**DAM SAFETY REVIEW**

WILTON ROAD DAM

CATARAQUI REGION  
CONSERVATION AUTHORITY

MAY 2006

SCALE	1:50	DATE	MARCH 2006
DRAWN BY	M.S.A.	REV. NO.	A
DESIGNED BY	S.F.	DRAWING NO.	WIL-03D
CHECKED BY	M.H.N.

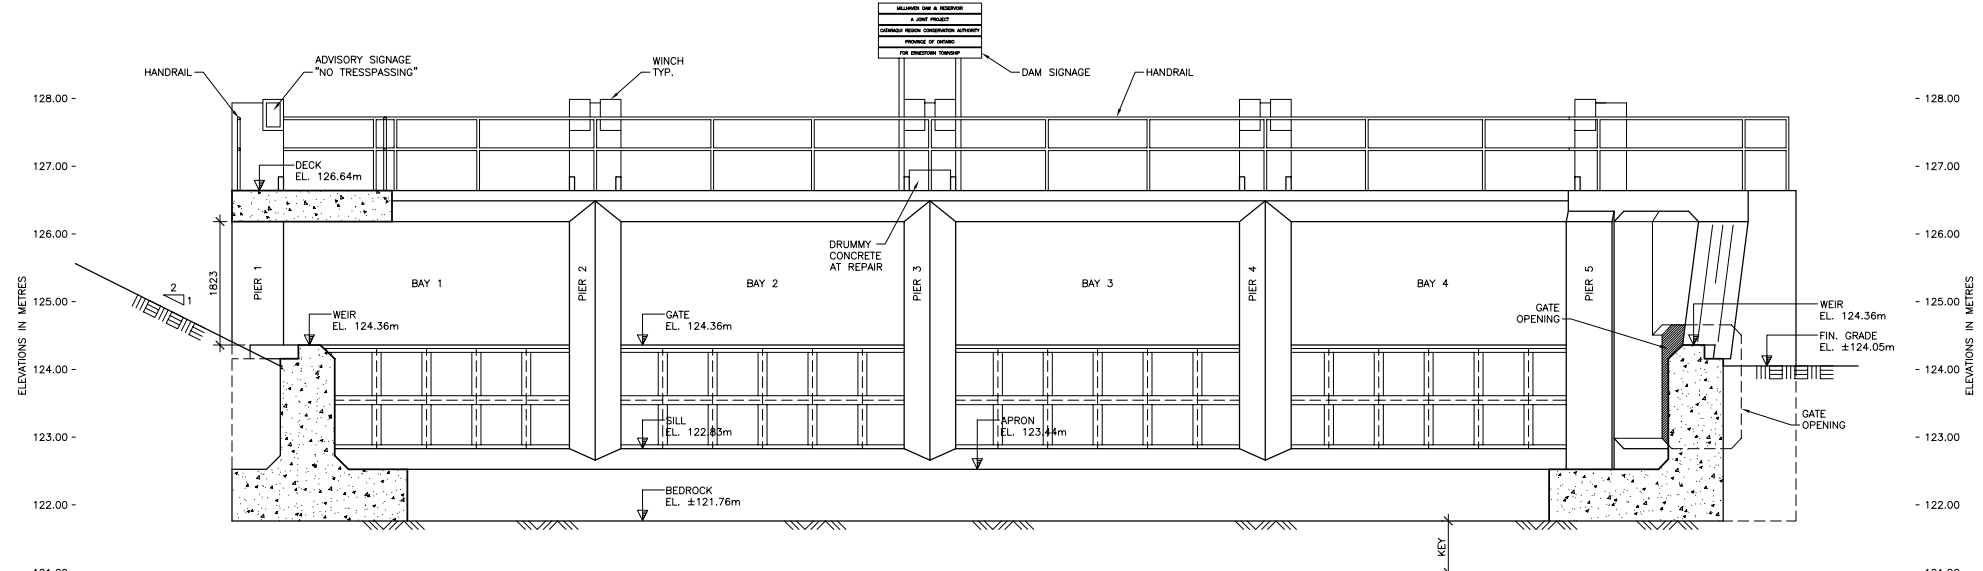
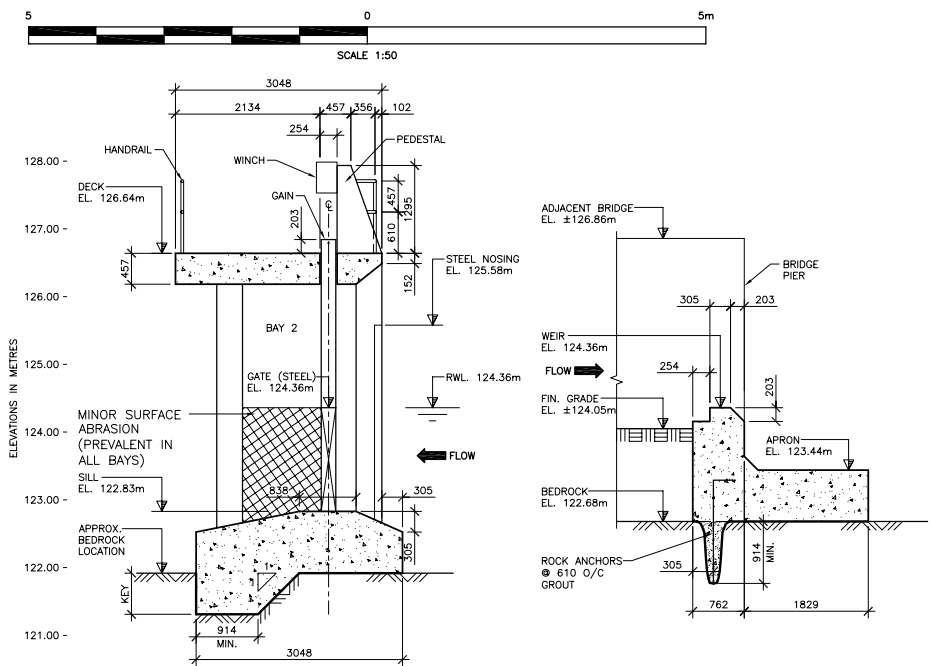
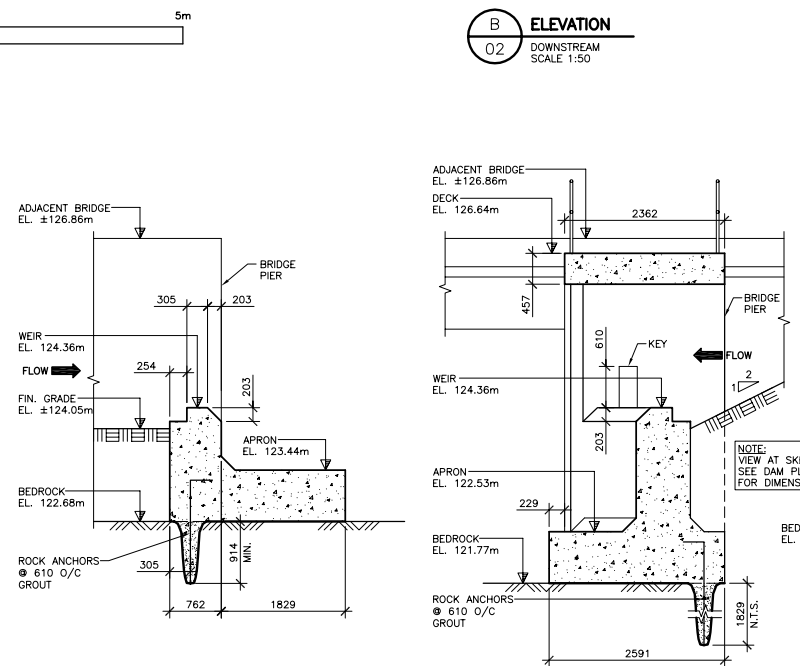
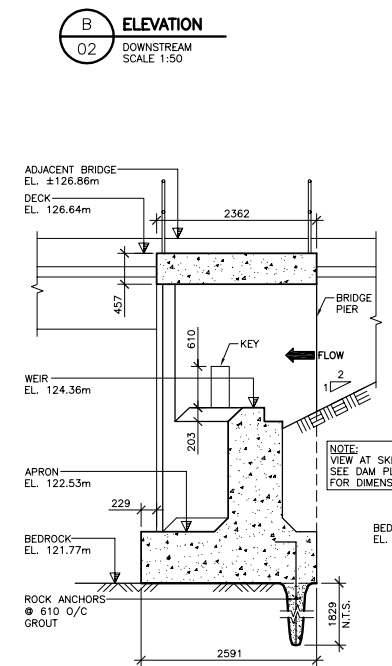
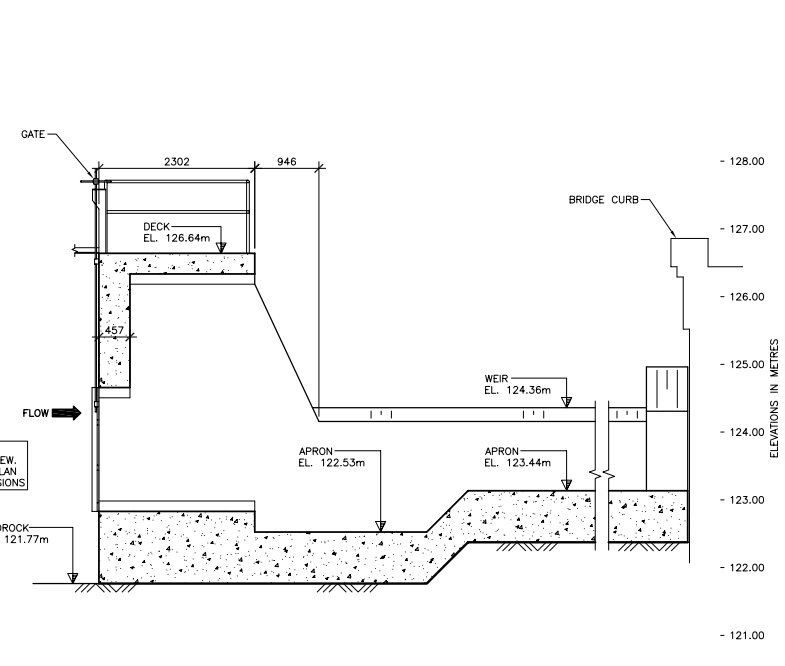
Deficiencies identified during the visual inspection have been illustrated on drawing WIL-03D in Appendix D.

E  
02
NORTH WEIR  
 SCALE NTS

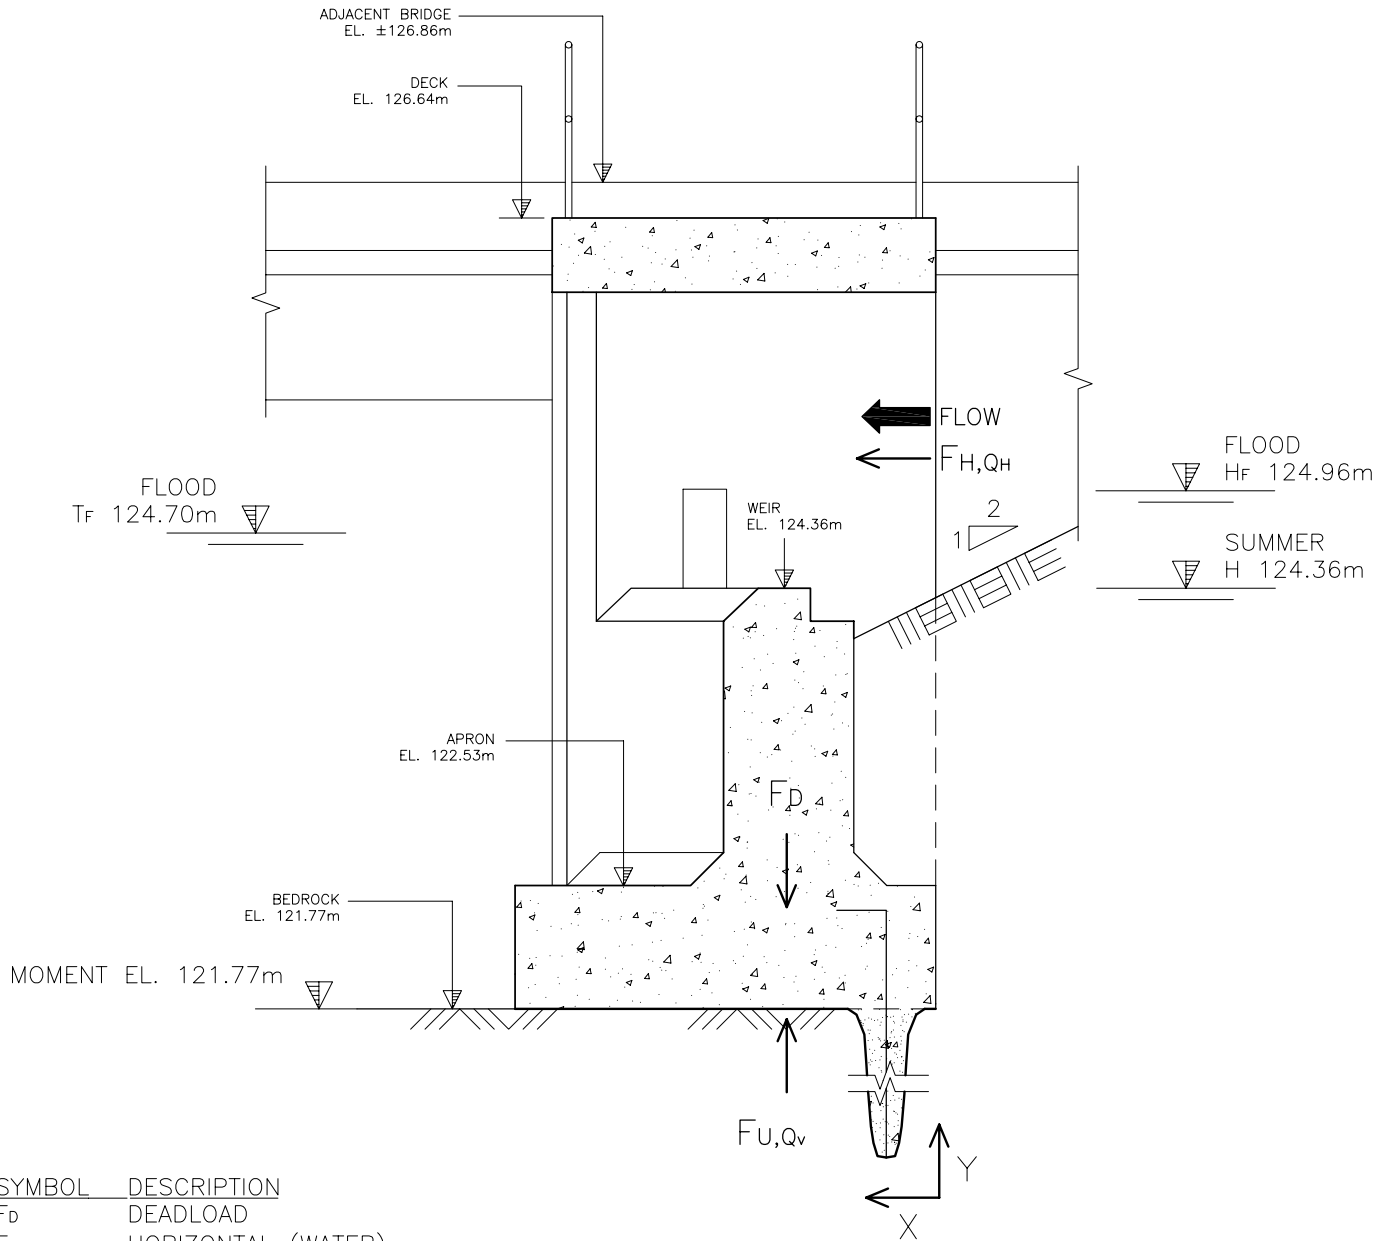
Does not meet criteria for resultant being in mid-third of structure.

The safety factor for sliding was found inadequate under all conditions. The resultant is also out of the mid-third under normal conditions. Note: we have ignored the anchor bolts shown on the drawing. However, considering the structure as a whole, the weir is short, anchored to the bridge and control structure piers so it is considered to be safe.

**1 GATE LOCKING MECHANISM**  
CONTROL STRUCTURE  
SCALE 1:25

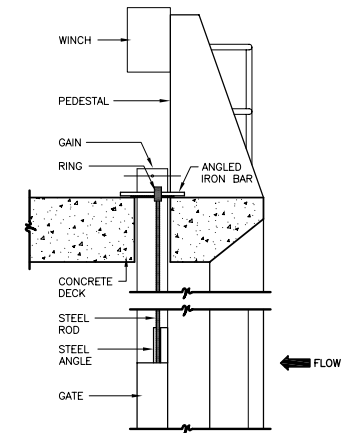
The present methodology of suspending the gates on the winch cables during the winter period needs to be reviewed. This provides stress on the cables. A device to lock the gates in the fully open position would provide the cable with a longer life expectancy and reduce the likelihood of damage as a result of vandalism (i.e. persons cutting the cable).

A device should be used to lock the gates in the open position during winter conditions that reduces the stresses on the winch cables and thereby lengthen their lifespan. A ring would be installed at each end of the gates and matching holes cut in the gain covers. When the gates are lifted, the ring would pass through these holes and then an angled bar placed inside that extends over the gain cover. This would create slack in the winch cables. A diagram of the device is provided in drawing WIL-03R.
